# 1968 Corvette: Service Bulletin: Cracking of the Plenum at the Right Hood Latch Plate

**Source:** Chevrolet Dealer Service Technical Bulletin

**Bulletin No:** 68-T-68

**Date:** Nov. 11, 1968

**RIGHT HOOD LATCH REINFORCEMENT PLATE INSTALLATION**  
**1968 CORVETTE**

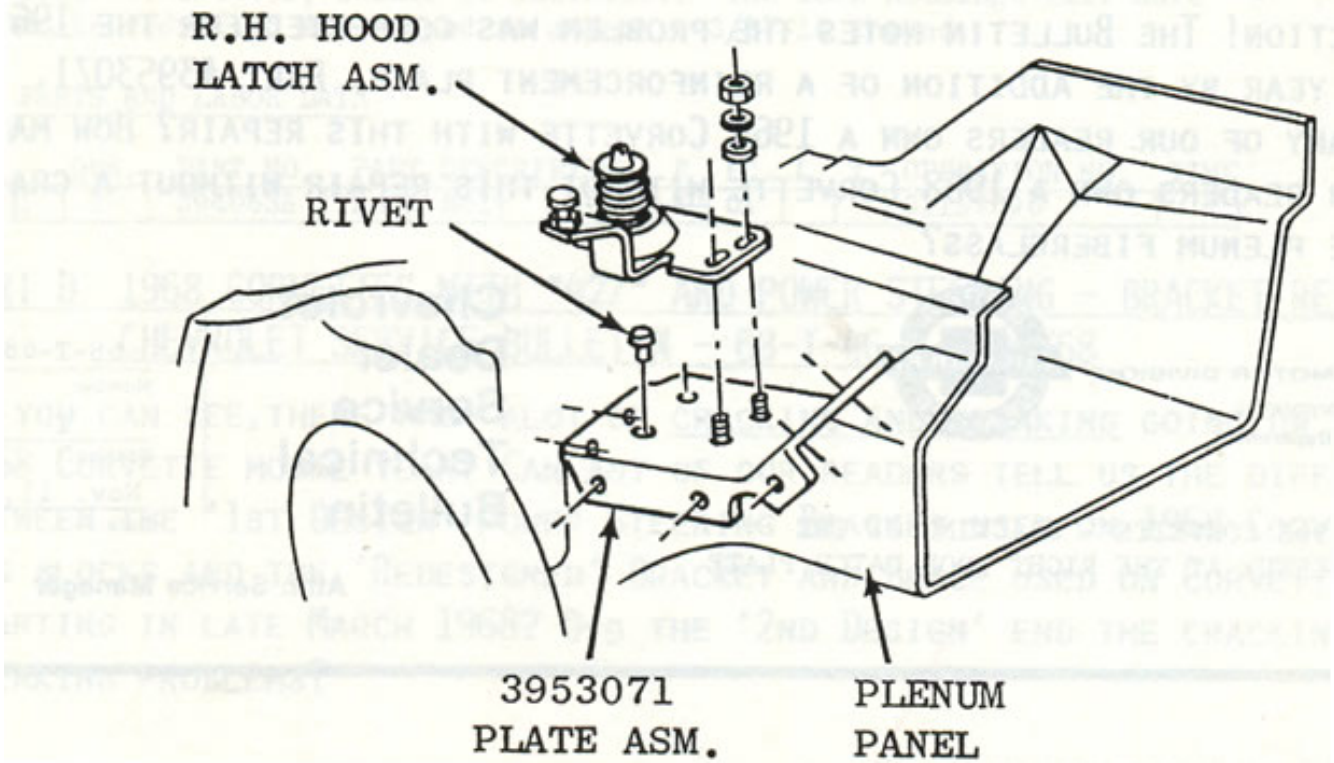
Cracking of the fiber glass plenum in the area of the right hood latch may be experienced on some 1968 Corvettes. This cracking is due to the manufacturing process of the plenum causing a glass rich condition in this area. This condition was corrected at the start of the 1969 production by the addition of a reinforcement plate to the area.

Whenever this cracking condition is encountered in the field, it may be corrected by riveting a reinforcement plate Part No. 3953071 to the outer surface of the plenum as outlined under Service Procedure.

1. Remove right hood latch assembly from the plenum panel and remove cowl vent grille.
2. Drill out two rivets retaining existing stud plate to plenum using a 7/32" dia. drill bit. Remove stud plate through cowl vent opening.
3. Position reinforcement plate on plenum as shown in sketch and drill seven (7) holes 7/32" dia. at hole locations in plate. The two (2) outboard holes are not accessible for drilling.
4. Attach the reinforcement plate to the plenum using 3/16" x 5/8" "Pop" Rivets.
5. Install and adjust right hood latch assembly as outlined in the August 1968 issue of "Chevrolet Service News." Install cowl vent grille.
